MESC TECHNICAL NEWS

No.M740-15-9910

Attention of USB MCU software for Apple PC

Fig. 1 Description of error operation at Control transfer

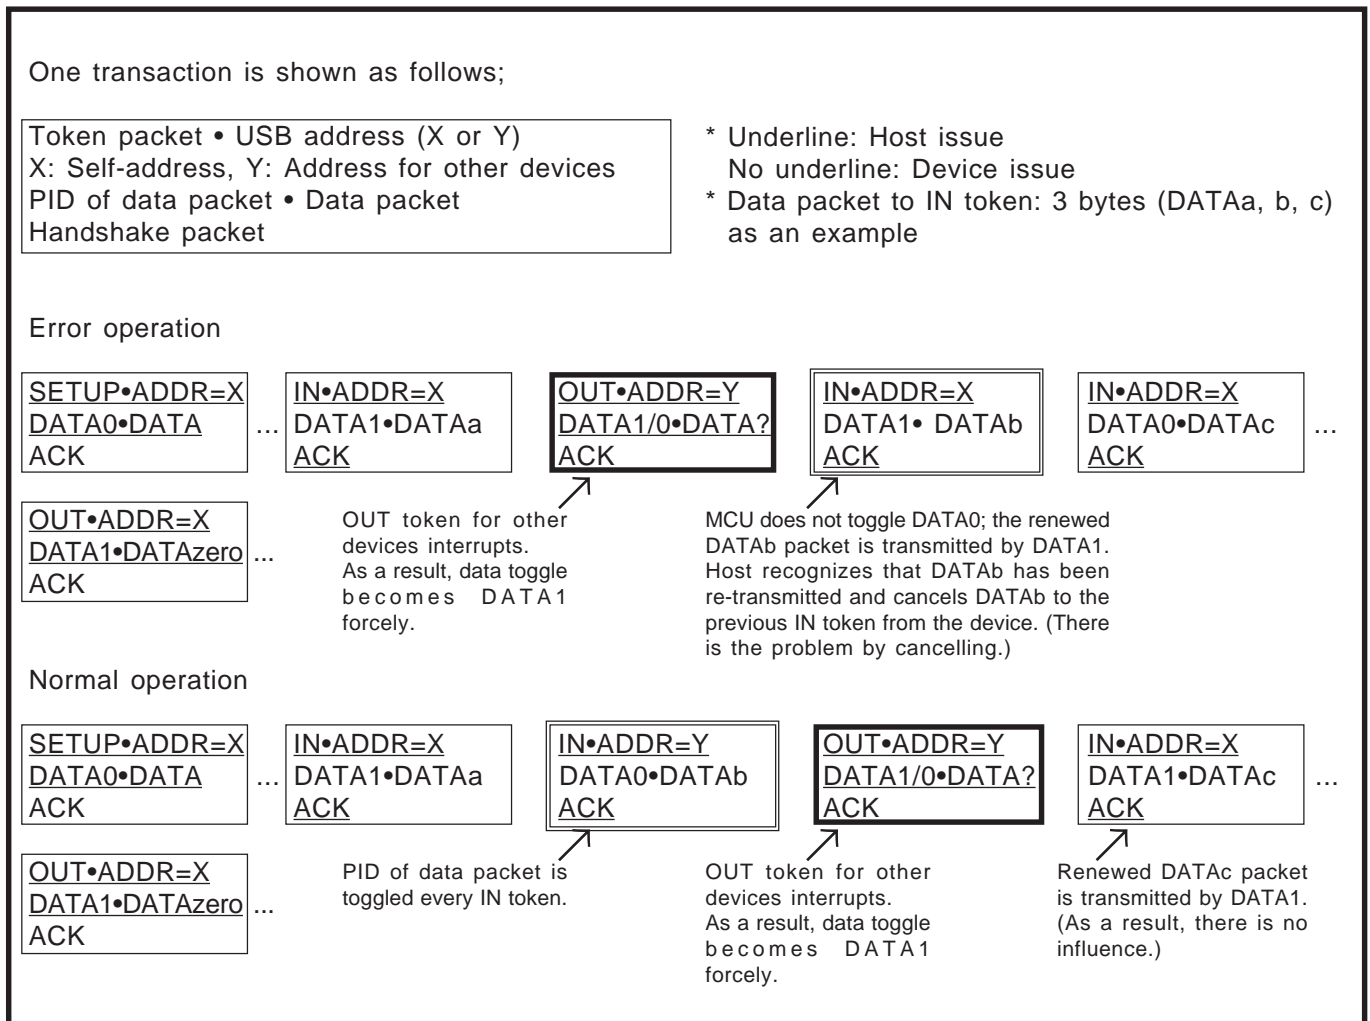
When the USB MCU is connected to Apple PC (PC with MacOS), in the Control transfer of Endpoint 0, the case in which the transaction is handled in order shown by Figure 1 might happen. In this case, the toggle function of the USB function in the 7532/7536 Group may be failed. (Enumerate may be failed in Enumerate.)

Fig. 2 MCU software flow chart for preventing problem (add to main routine)

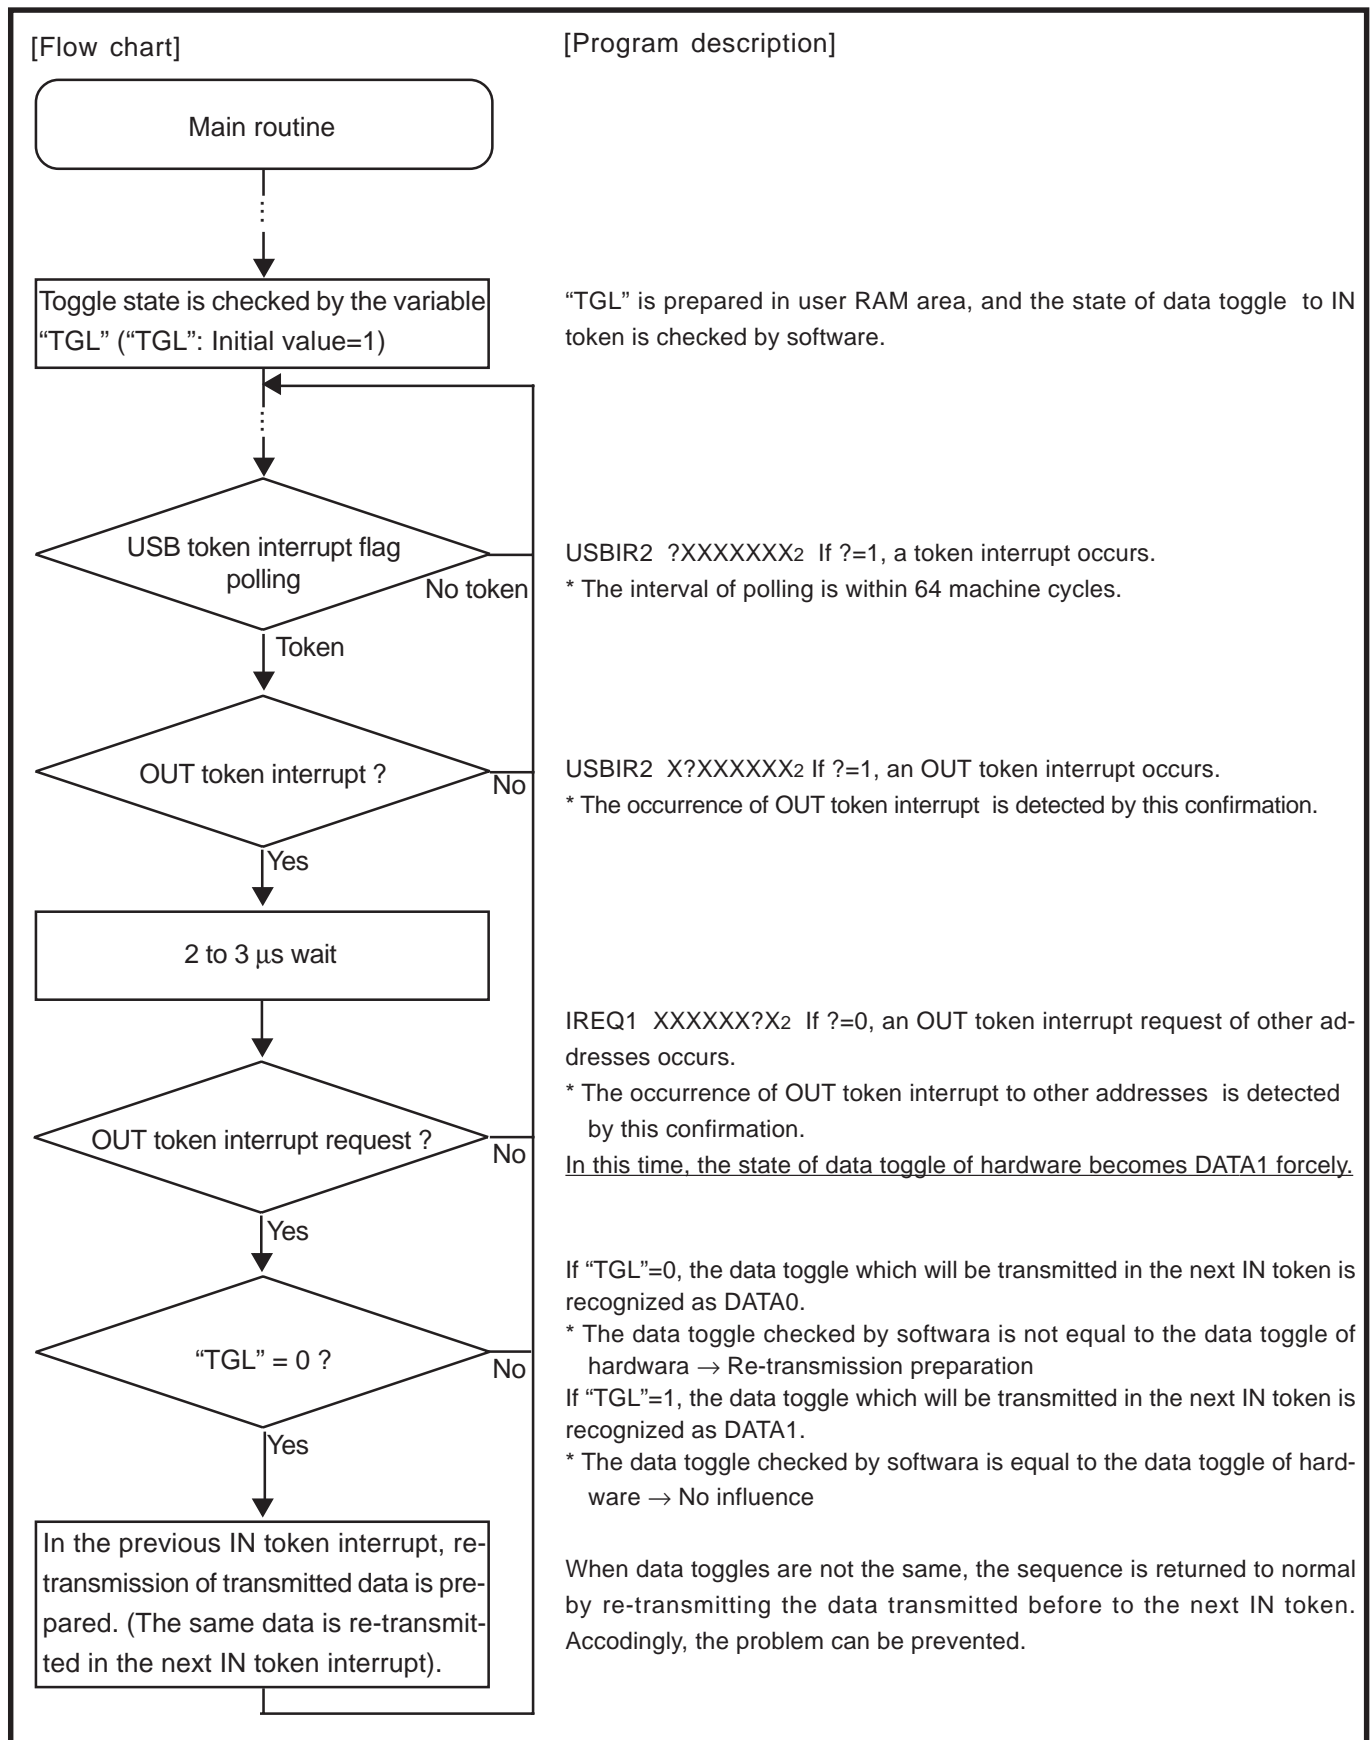
Change the software of MCU according to the flow chart in Figures 2 and 3 to prevent this problem.

Fig. 4 Comparing the error operation at Control transfer with the operation after software countermeasures

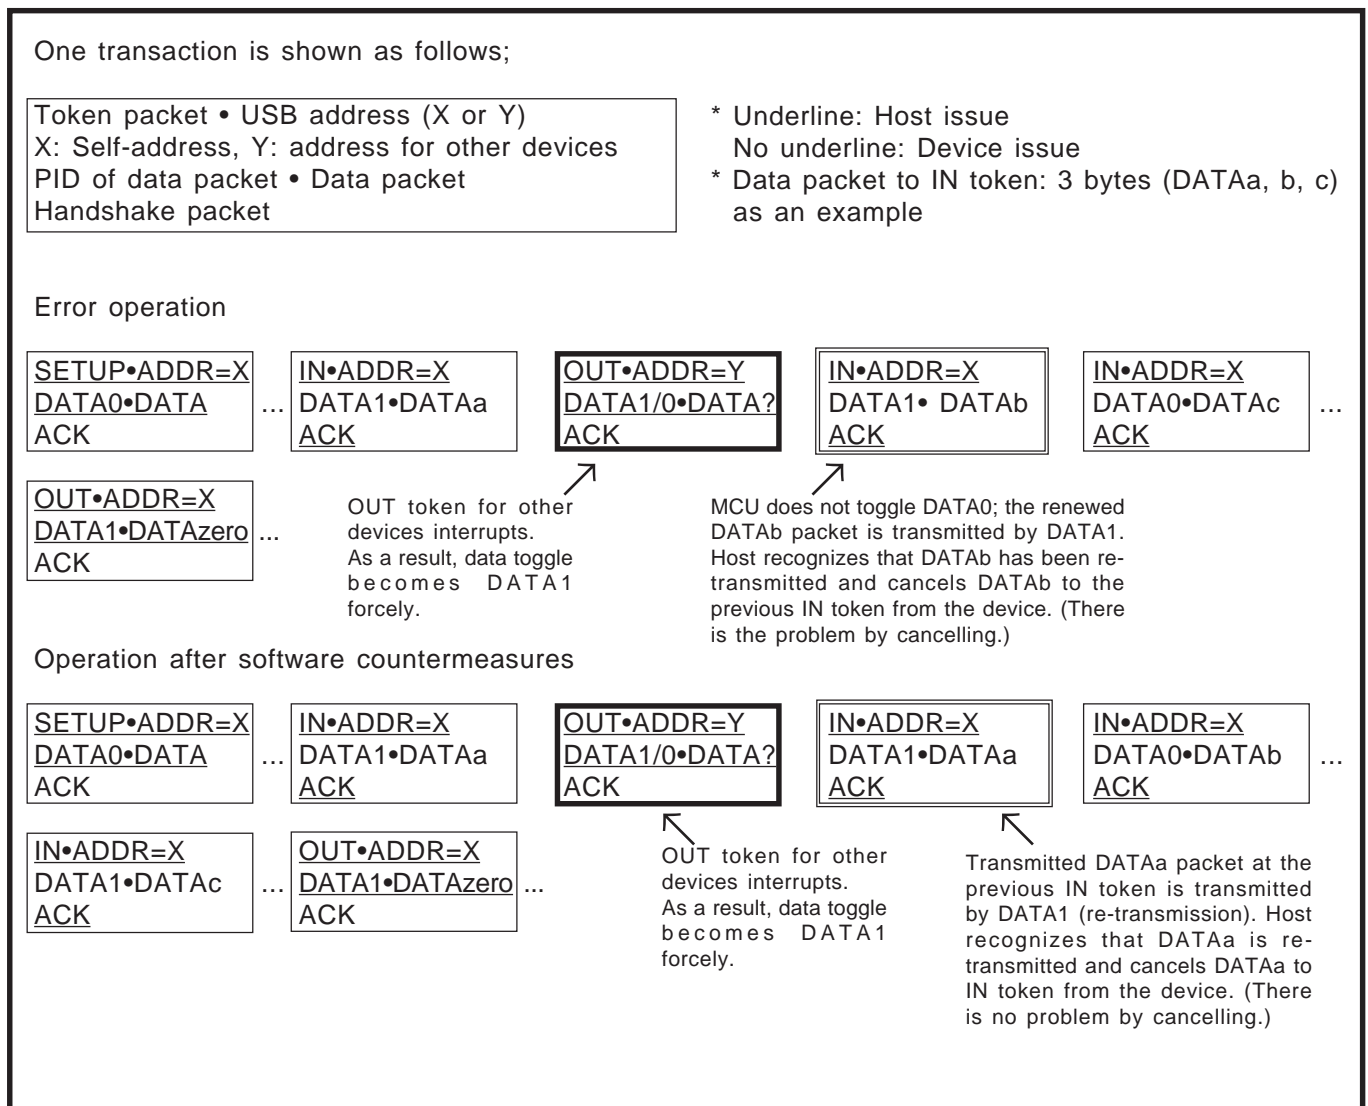
3. Operation after software countermeasures
